**Franciscan Renewal Center
5802 N Lincoln Dr
Major Special Use Permit Amendment
(SUP-26-02)
Recommendation Meeting**

**Planning Commission
June 16, 2026**

6/2 STUDY SESSION

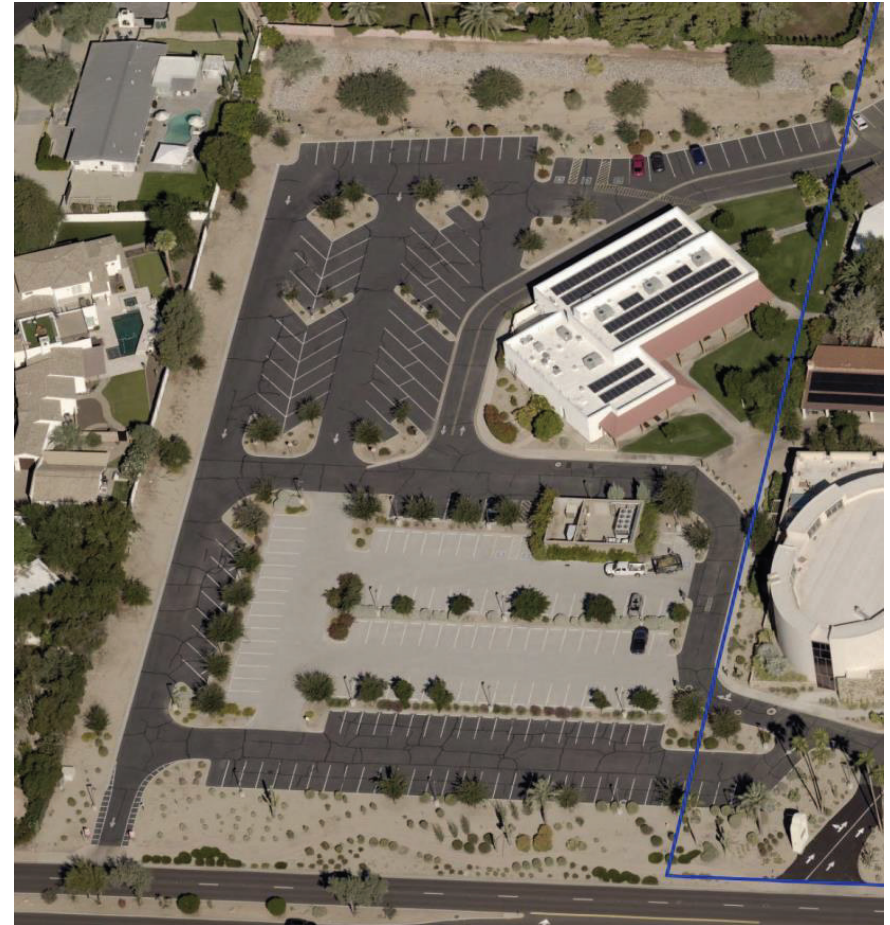
- Setback of Array Four (not meeting 60' SUP Guideline).
 - **RESPONSE: Applicant removed Array Four.**
- Overall maximum height was also a concern of the Commission.
 - **RESPONSE: Lowered the three remaining arrays by 1'.**
- The vegetation screening plant palette (Willow Accacia and Red-tip Photinia) was not sufficient, per Commission comment.
 - **RESPONSE: Added stipulation Number Three.**
- The Commission requested that the array designer/engineer attend the June 16th meeting to discuss the proposal.

SETBACKS

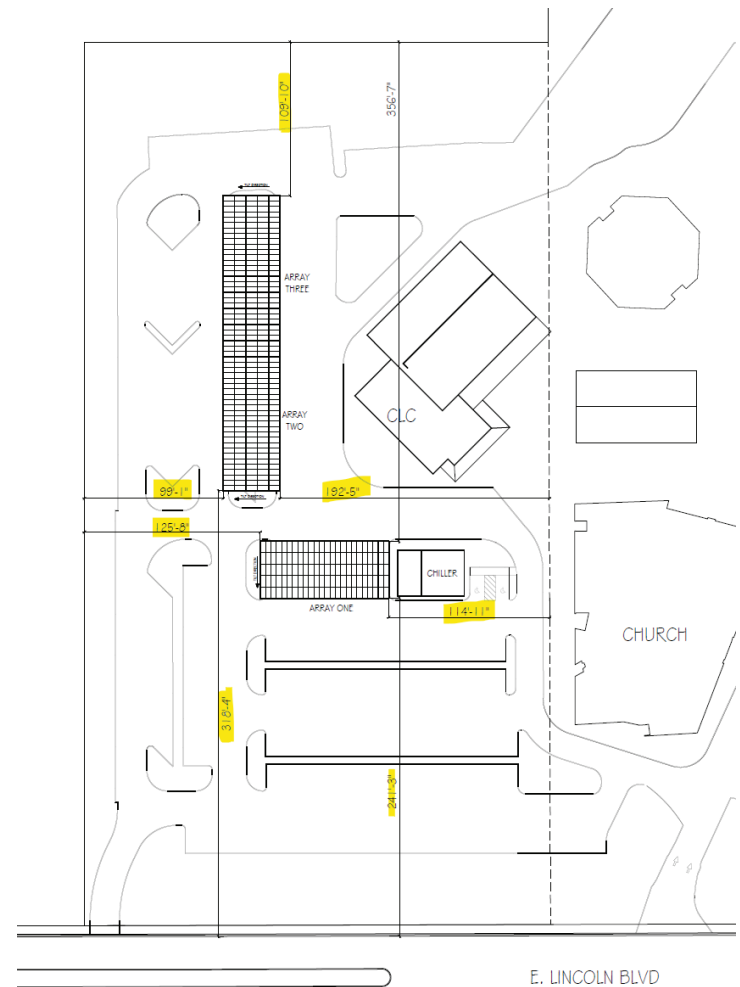
SOD - The Planning Commission shall explore appropriate setbacks for the proposed shade structure.

- All three structures compliant with SUP Guidelines:
 - 60' adjoining residential and 40' adjoining public street.
- Exploring appropriate setbacks for the proposed shade structure.

LANDSCAPING

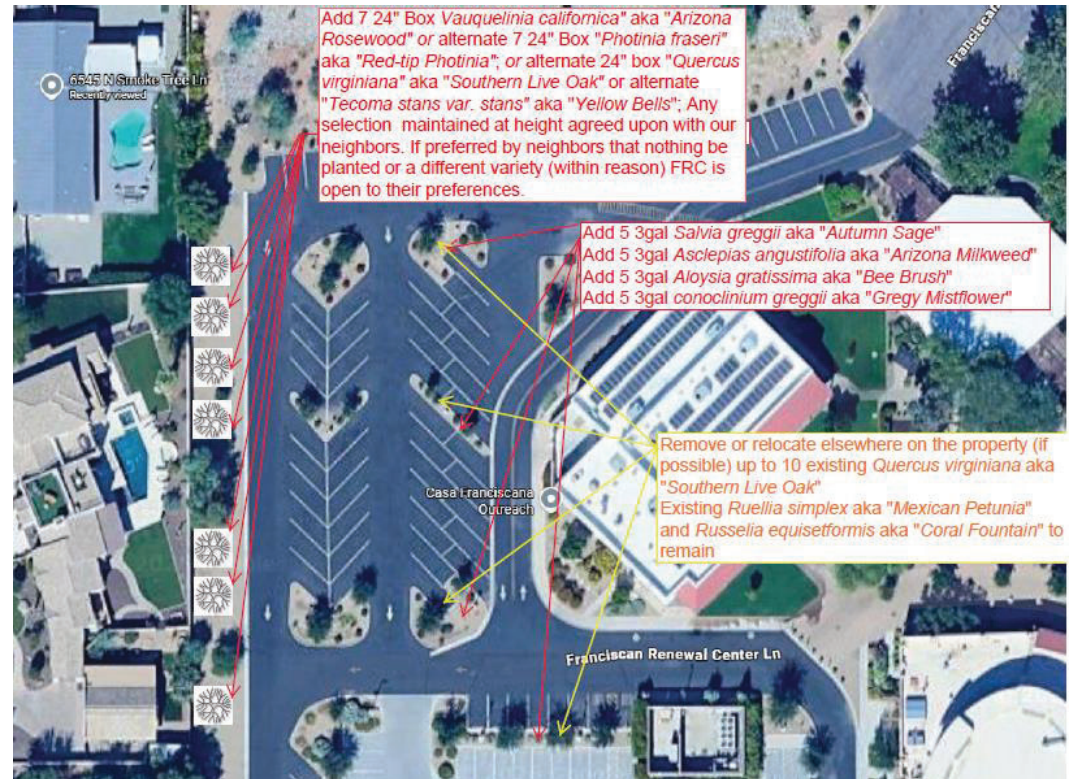
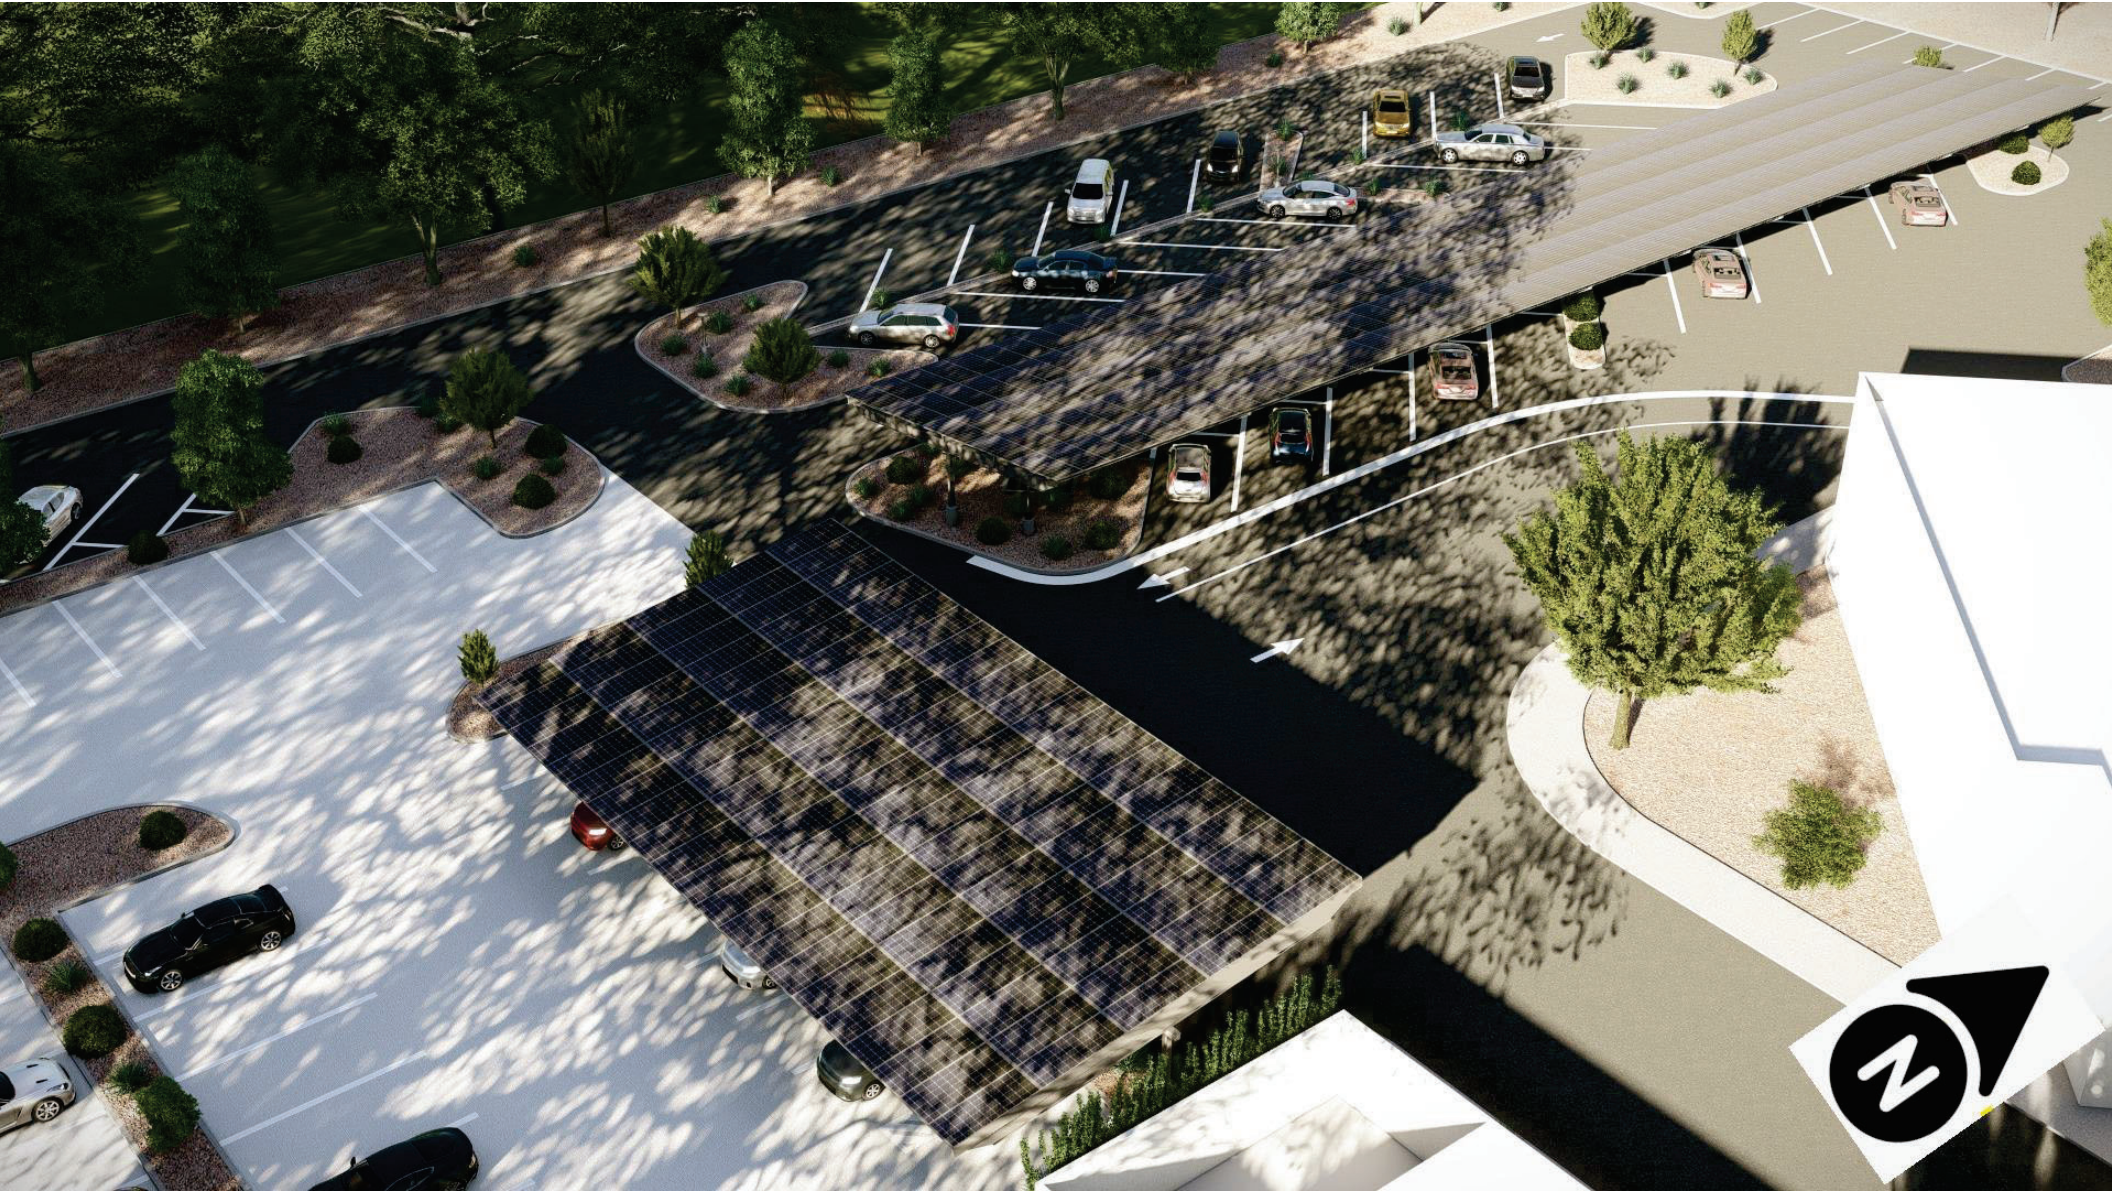
1. Remove or relocate 10 trees.
2. Plant an additional 20 pollinators and milkweed in place.
3. Stipulation Three added: Screening at the request/direction of the residences to the west.
 1. To be selected from Visually Significant Corridor Plan (Patterns of Nature list)
